December 5, 2024

PROJECT NAME: IGLESIA CRISTIANA FE Y ESPERANZA

PROJECT NUMBER: 2014010022

APPLICATION: MINOR SITE PLAN #31560

PROPOSED PLANS FOR MINOR SITE PLAN

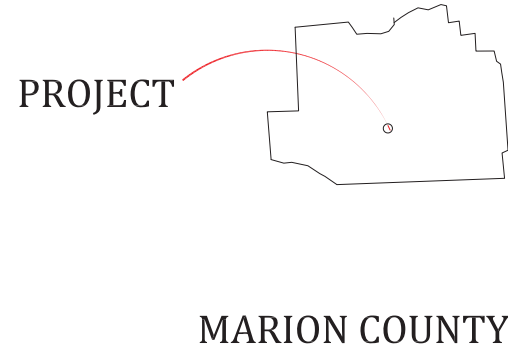
- 3 DEPARTMENT: ZONE - ZONING DEPARTMENT
REVIEW ITEM: Additional Zoning Comments
STATUS OF REVIEW: INFO
REMARKS: Cover sheet points to Levy County and Levy County's boundary is shown as Marion County. Please correct.

- 10 DEPARTMENT: ZONE - ZONING DEPARTMENT
REVIEW ITEM: 2.12.4.C - Owner and applicants name
STATUS OF REVIEW: NO
REMARKS: 6/12/24 - Include the owner and applicant names on the cover sheet.
11/22/24 - submit SunBiz to show applicant is a signee for Faith and Hope Temple.
11/22/24 - is shown on the application and resubmittal

- 11 DEPARTMENT: ZONE - ZONING DEPARTMENT
REVIEW ITEM: 2.12.4.L(1) - Parcel number
STATUS OF REVIEW: NO
REMARKS: 6/12/24 - Include the parcel number on the cover sheet.
11/22/24 - missing the parcel ID # on the Minor Site Plan submitted on 11/12/24

PAGE 63
ENGINEERING

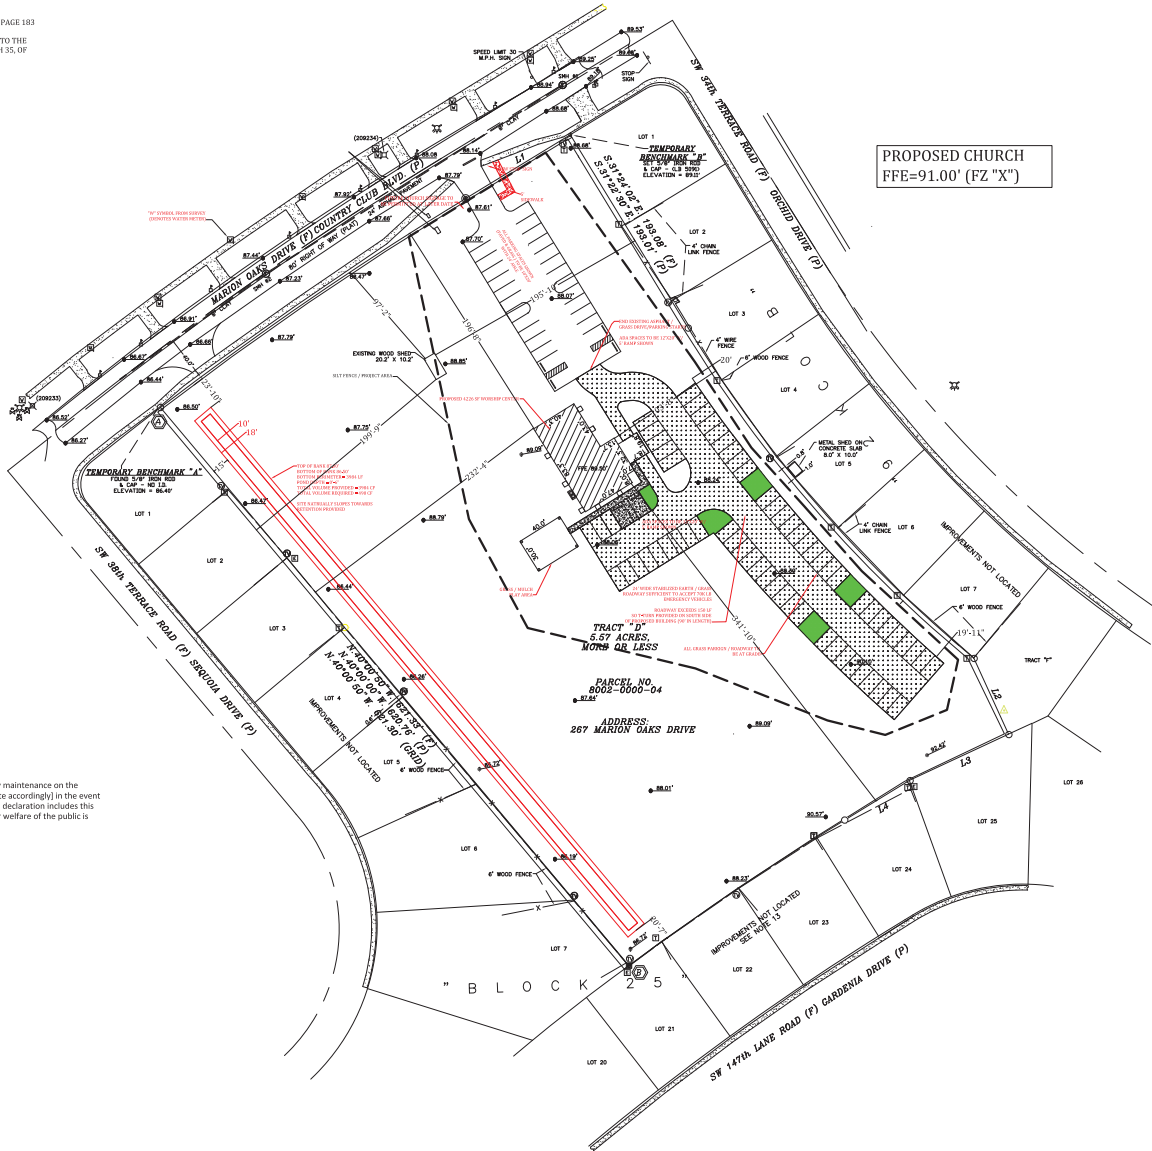
- 12 DEPARTMENT: ZONE - ZONING DEPARTMENT
REVIEW ITEM: 2.12.4.L(4) - Zoning requirements: lot width, area, setbacks, coverage (floor area ratios), and parking
STATUS OF REVIEW: NO
REMARKS: 6/12/24 - Need to include lot width, existing and proposed setbacks.
11/22/24- mark the lot width front and rear along with the depth property lines to the east and west on your minor site plan.
include the setbacks from all the nearby property lines to all structures on the minor site plan.

- 13 DEPARTMENT: ZONE - ZONING DEPARTMENT
REVIEW ITEM: 2.12.23/4.2 - Setbacks, dimensions for all improvements, and easements
STATUS OF REVIEW: NO
REMARKS: 6/12/24 - provide dimensions off all existing and proposed improvements.
11/22/24- mark all setbacks on the one minor site plan to all existing and proposed structures.

- 14 DEPARTMENT: ZONE - ZONING DEPARTMENT
REVIEW ITEM: 2.12.24 - Landscape requirements, (buffering) 6.8.6
STATUS OF REVIEW: NO
REMARKS: 11/22/24- must show on the minor site plan the buffer types for commercial use - see section 6.8.2 (K) ROW buffer must be type C and the south, west and east property lines must show you are using Buffer Type B's

- 18 DEPARTMENT: FRMSH - FIRE MARSHAL REVIEW
REVIEW ITEM: NFPA 1 Chapter 18.2.3 - Fire Dept Access Roads
STATUS OF REVIEW: NO
REMARKS: Parking lot extends 216' feet, which is considered part of the fire apparatus access road and is excess of 150 feet and requires a turnaround.

- 19 DEPARTMENT: ENGTRF - TRAFFIC REVIEW
REVIEW ITEM: 6.11.9.B - Traffic signs
STATUS OF REVIEW: NO
REMARKS: 11/14/24 - Provide stop sign details - include geometry of sign and mounting specifications. See 7.3.1 TS031 for an example.
6/17/24 - Provide a 30" stop sign at the driveway placed 4' behind the crosswalk.

- 20 DEPARTMENT: ENGTRF - TRAFFIC REVIEW
REVIEW ITEM: 6.11.9.C - Pavement marking
STATUS OF REVIEW: NO
REMARKS: 11/14/24 - Show stop bar specifications. See 7.3.1 TS030 for an example.
6/17/24 - 1. Show the dimensions of the parking. The regular parking is required to be 9' wide by 18' long. The handicap parking is required to be 12' wide by 18' long with a 5' wide access aisle next to the handicap spot. 2. Mark all handicap parking including new and existing. 3. Provide a stop bar at the driveway placed 4' behind the crosswalk.

ENGINEERING
PAGE 4
SCALE: 1" = 50'

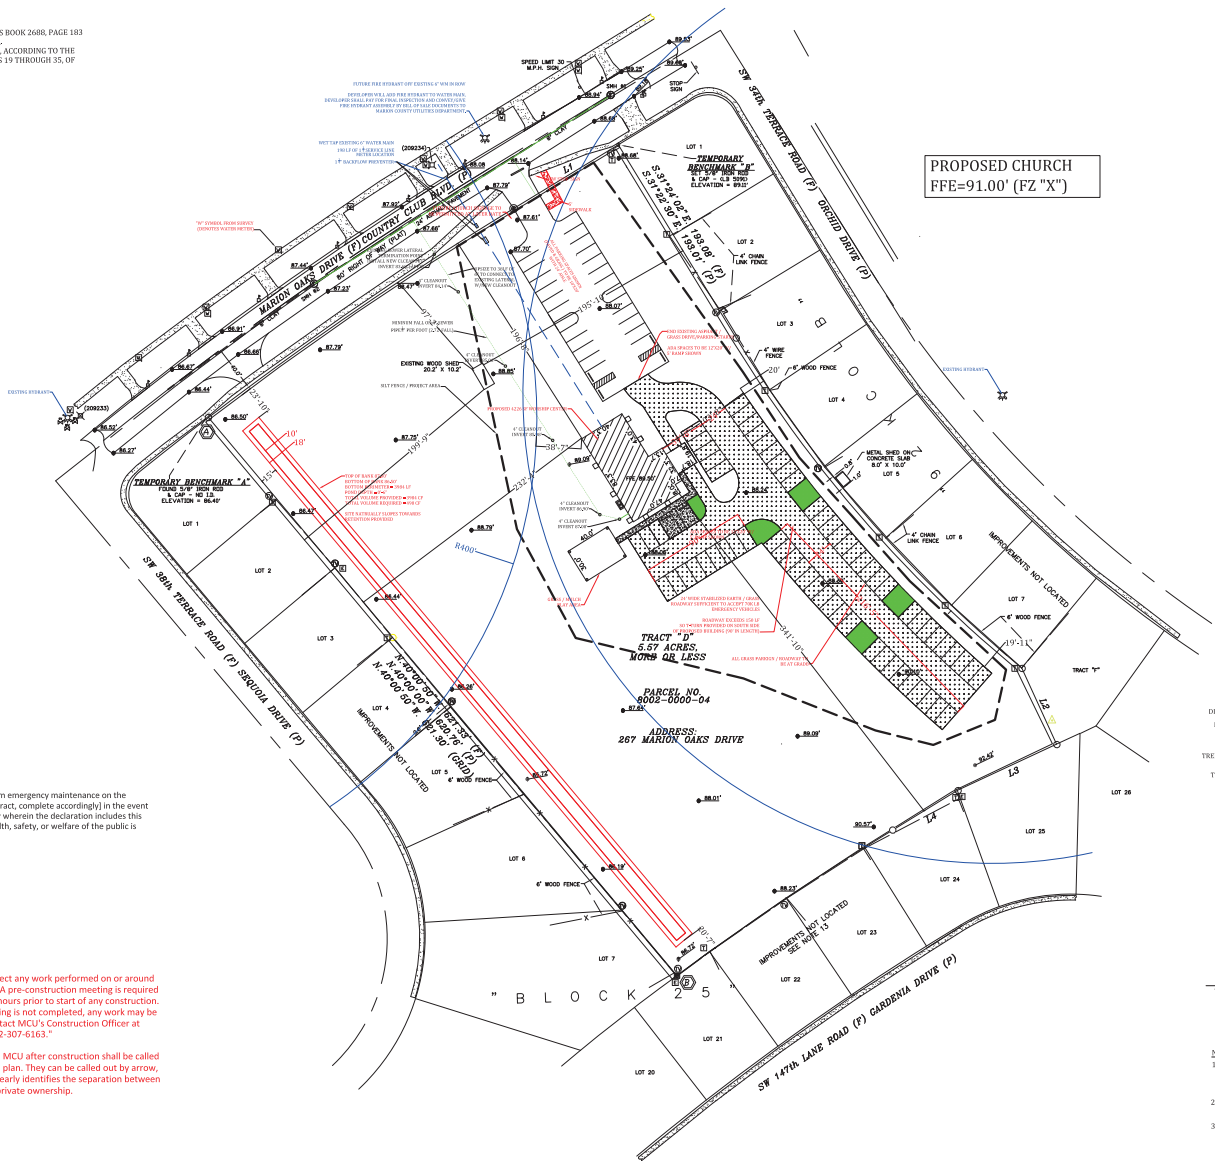
- 26 DEPARTMENT: UTIL - MARION COUNTY UTILITIES
REVIEW ITEM: 6.14.5.A(1) - Submittal Reqs - Existing on-site & off-site mains and service connections
STATUS OF REVIEW: NO
REMARKS: 11/25/24 review remains unaddressed; the copies of the pages referenced in the "UTIL" response is blurry & unreadable - identify where on which page the information can be found, or just answer in response. ORIGINAL COMMENT: (1) Show water main - page labeled "63" (2) some water features appear to be called out as "W" - identify where legend can be found (3) show water tap & meter location

- 30 DEPARTMENT: UTIL - MARION COUNTY UTILITIES
REVIEW ITEM: 6.15.5 - Water Service and Connection
STATUS OF REVIEW: NO
REMARKS: show water main tap and service placement - indicate size of service, size of meter

"MCU personnel are to inspect any work performed on or around existing MCU infrastructure. A pre-construction meeting is required to be held a minimum of 48 hours prior to start of any construction. If the pre-construction meeting is not completed, any work may be halted. To schedule, contact MCU's Construction Officer at 352-307-6163."

Any assets to be conveyed to MCU after construction shall be called out clearly on the Utility/Site plan. They can be called out by arrow, color or other method that clearly identifies the separation between public/private ownership.

LANDSCAPE PLAN
IGLESIA CRISTIANA FE Y ESPERANZA
MARION OAKS
MARION COUNTY
FLORIDA
SHEET 1222 of 1222

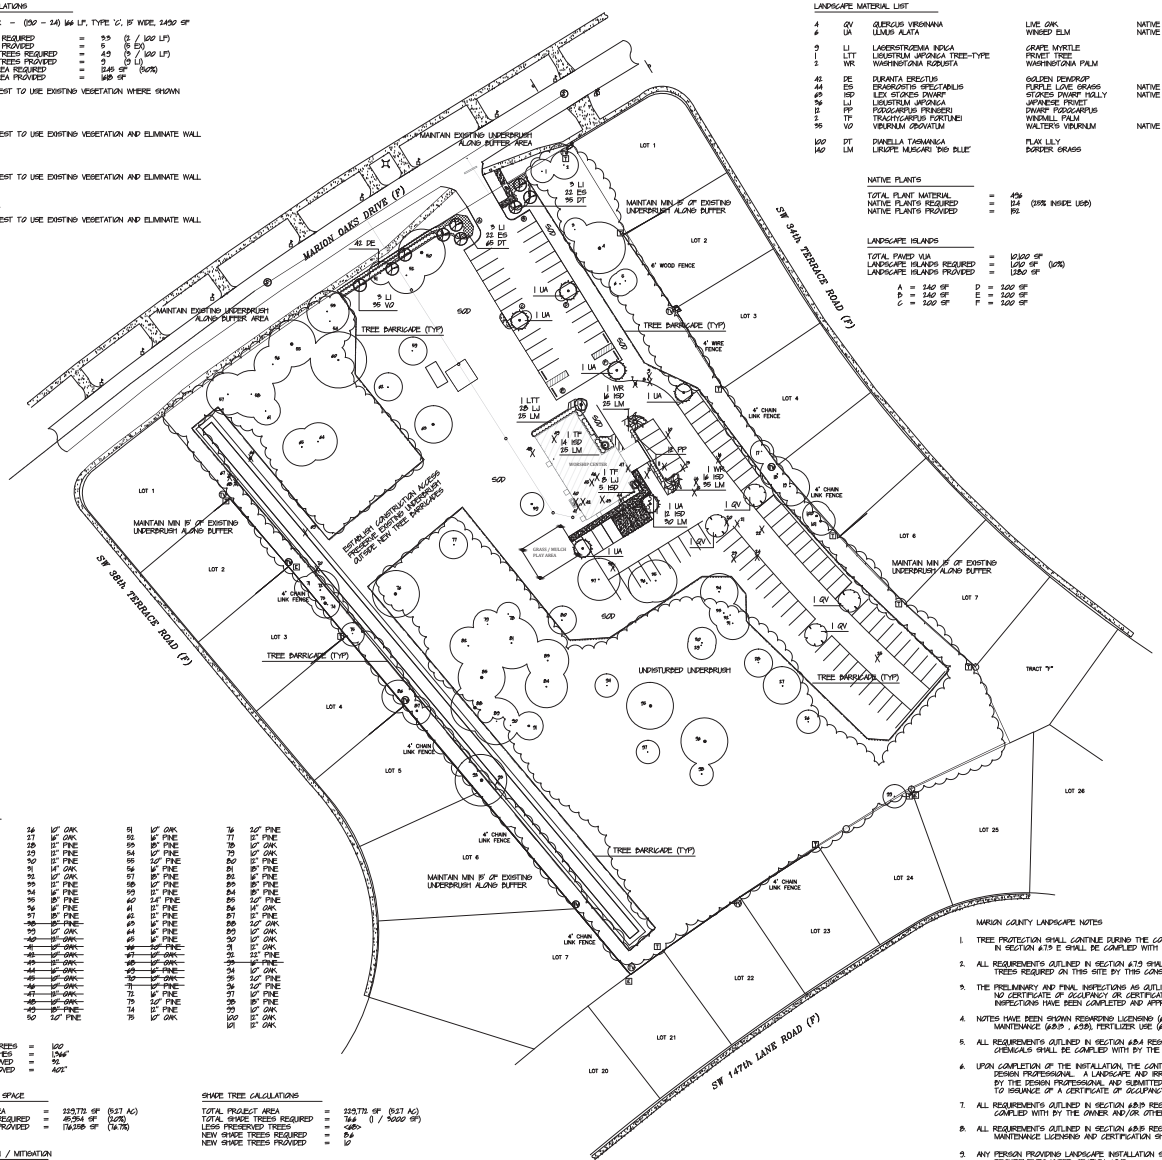
- 21 DEPARTMENT: LSCAPE - LANDSCAPE DESIGN AND IRRIGATION
REVIEW ITEM: 6.8.6 - Buffers
STATUS OF REVIEW: NO
REMARKS: 1. Clarify Contruction access area, will this be restored? 2. Is long rectangle near west buffer a DRA? 3. All buffers to be discussed with staff to determine if sufficient 4. Waiver needed for East, West and south buffers to use existing vegetation

- 24 DEPARTMENT: LSCAPE - LANDSCAPE DESIGN AND IRRIGATION
REVIEW ITEM: Additional Landscape comments
STATUS OF REVIEW: NO
REMARKS: 1. Landscape and irrigation plan shall be signed and sealed for submittal (6.2.1 & 6.9.2)

Section & Title of Code (be specific): 6.8.6 Buffers and 6.8.7 Buffers
Reason/Justification for Request (be specific): 6.8.6 North buffer - waiver to allow natural vegetation in areas shown. 6.8.6 East, West and South buffers - waiver to 1) allow to natural vegetation for all tree and shrub plantings, 2) Waiver of wall requirement because of natural vegetation. 6.8.7 Parking areas - Waiver of requirement for hedge plantings along parking areas because the fronts of the cars do not face the street and there is sufficient natural vegetation to screen all adjacent residential lots.
